Bid Memorandum No. 1 **(01-27-25)**

Project: Rochester Community Schools 2020 Sinking Fund
Scope: Adams High School Drainage
Construction Manager: Frank Rewold and Sons Inc.

ADAMS HIGH SCHOOL DRAINAGE REVISIONS
3200 W. TIENKEN ROAD
ROCHESTER HILLS, MI 48066

C-6.2

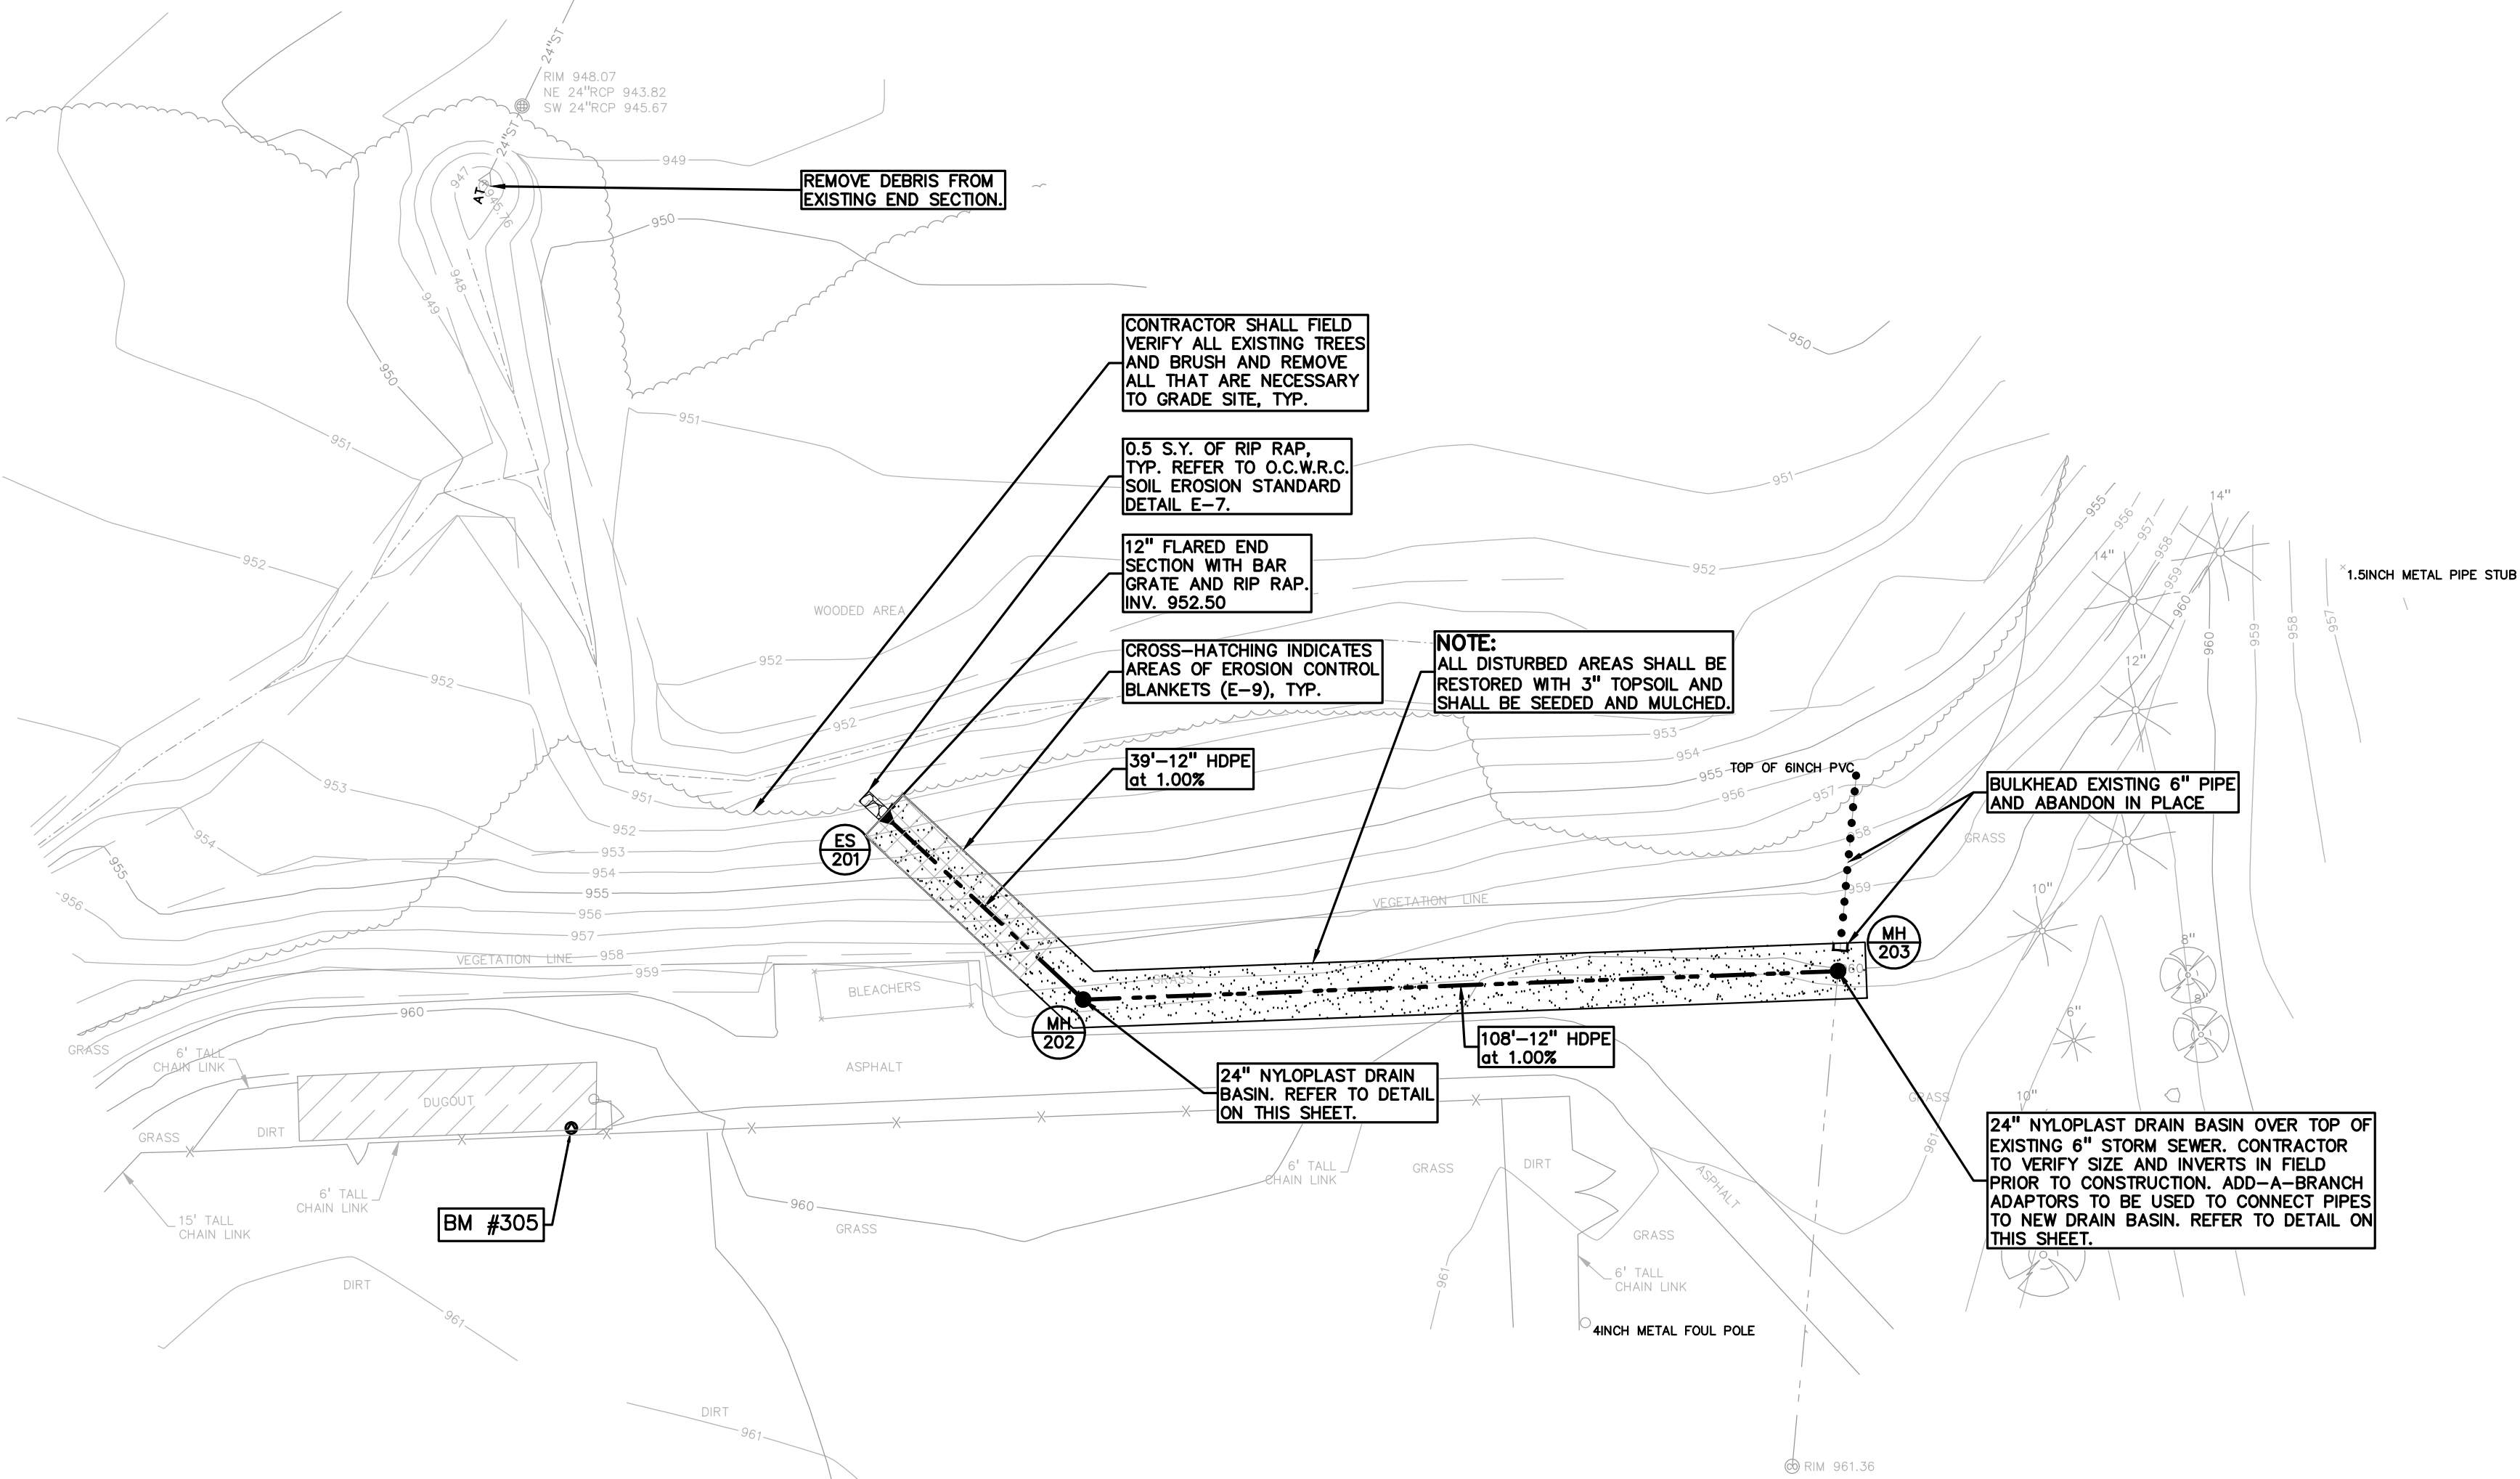
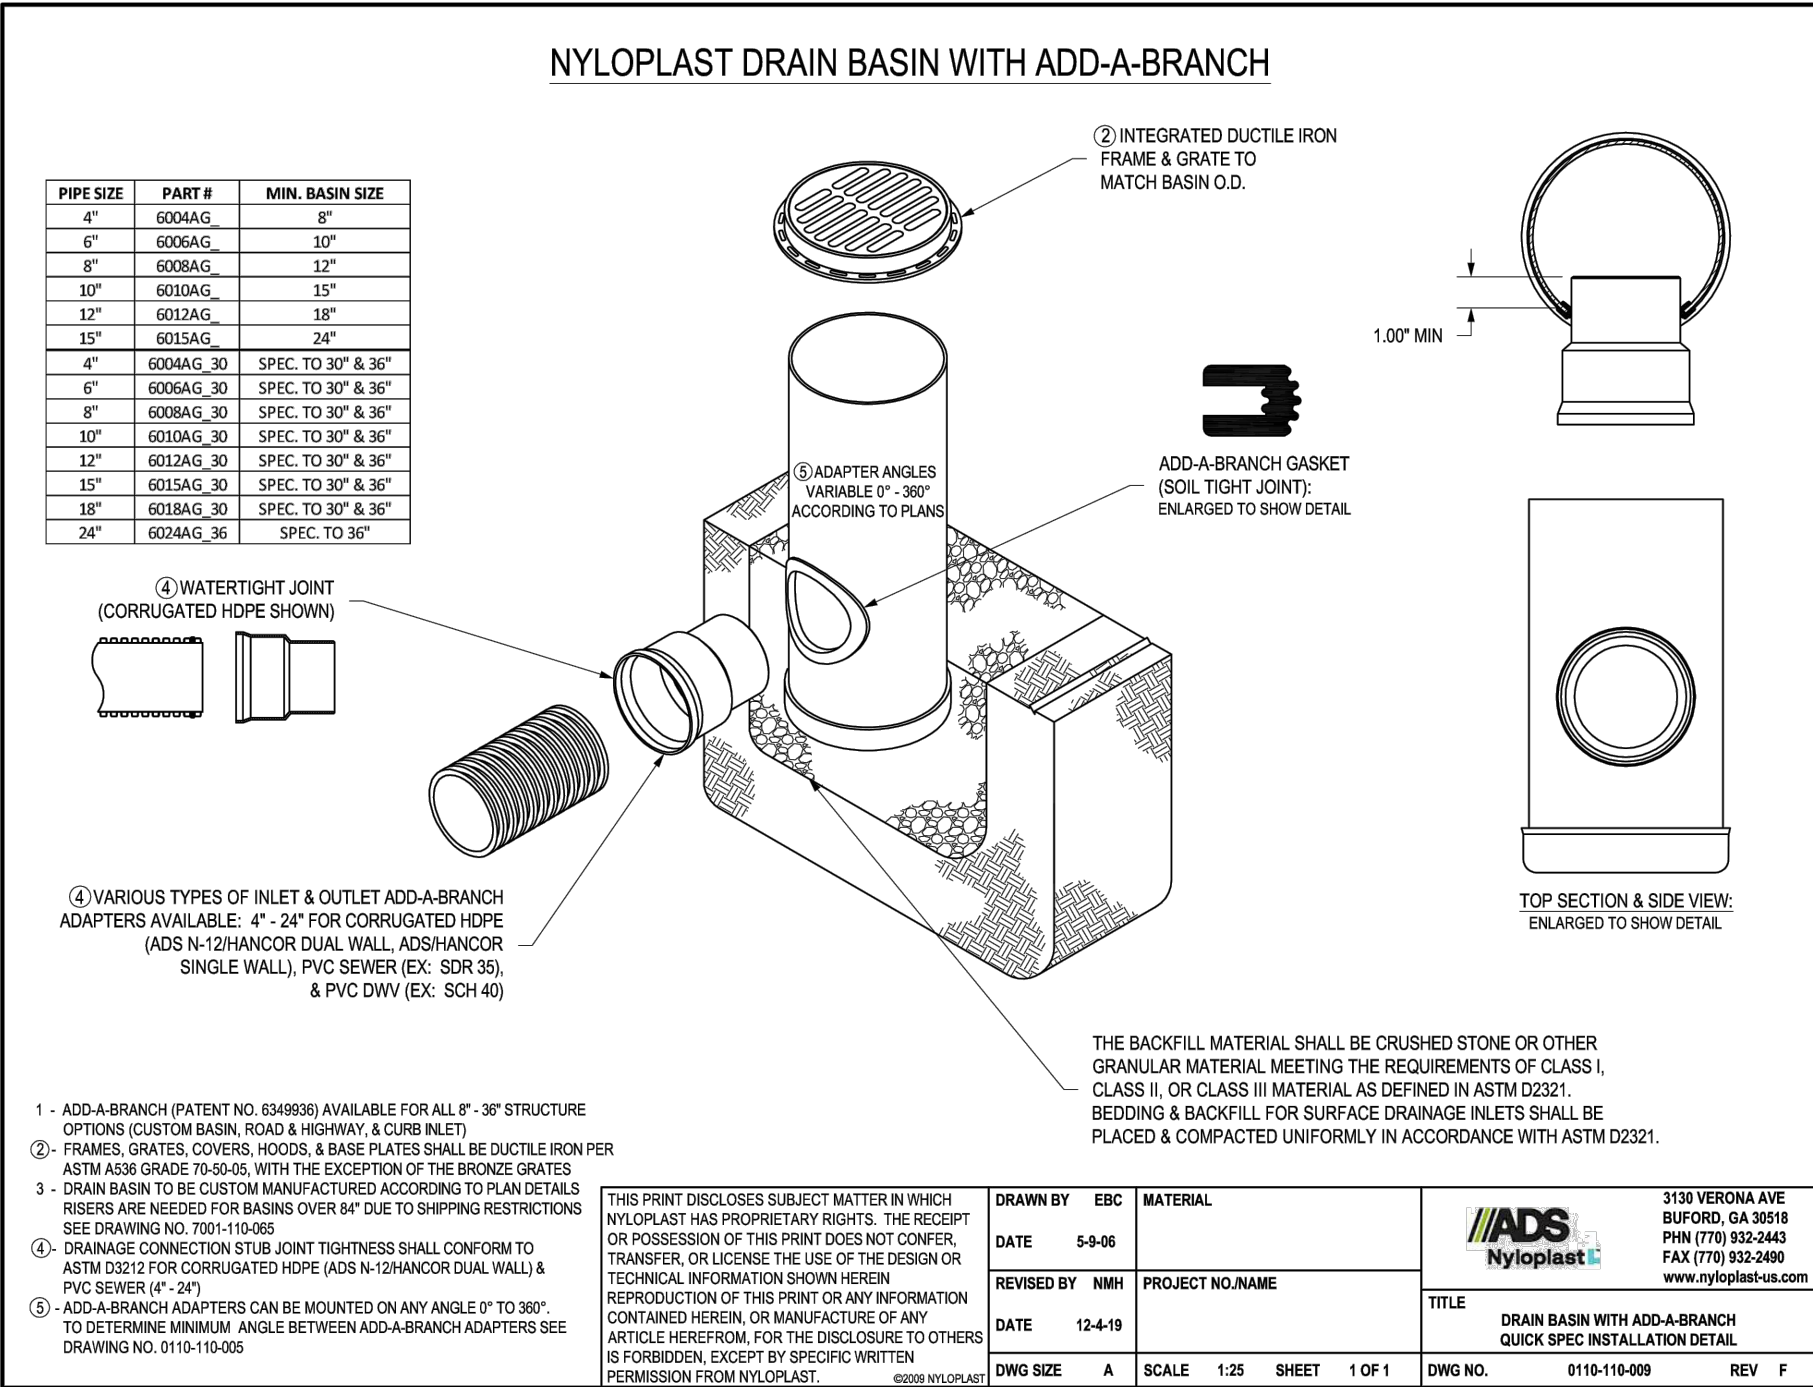
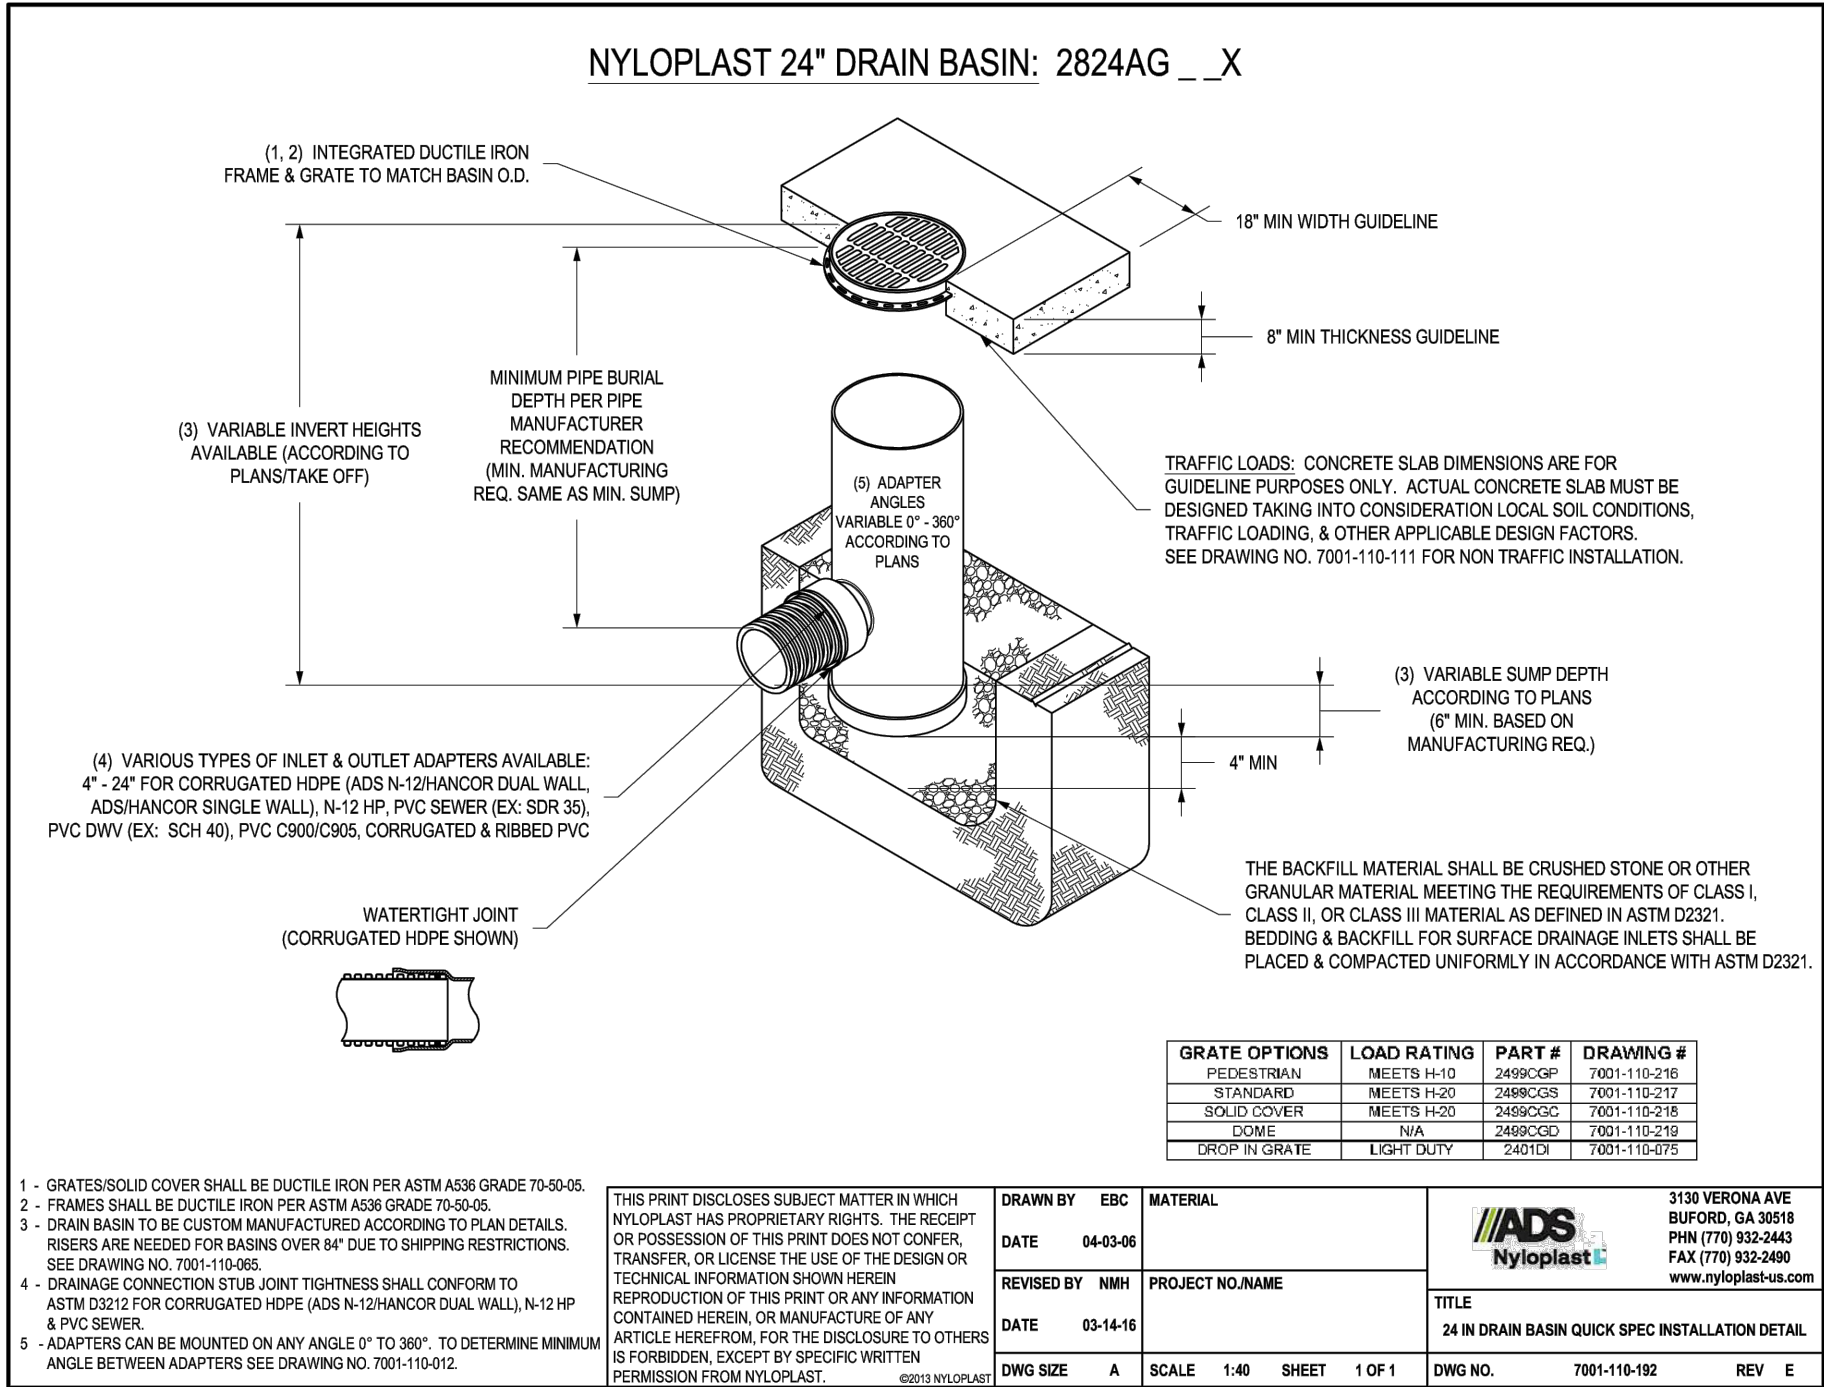
- P. Provide all work associated on sheet C-6.2 at Softball Field, this includes but limited to the following;
1. Remove debris from existing end section
 2. Remove all existing trees, brush etc. as necessary
 3. Restore all disturbed areas with topsoil, seed and mulch
 4. Furnish and install man holes and end section
 5. Provide rip rap at new end section
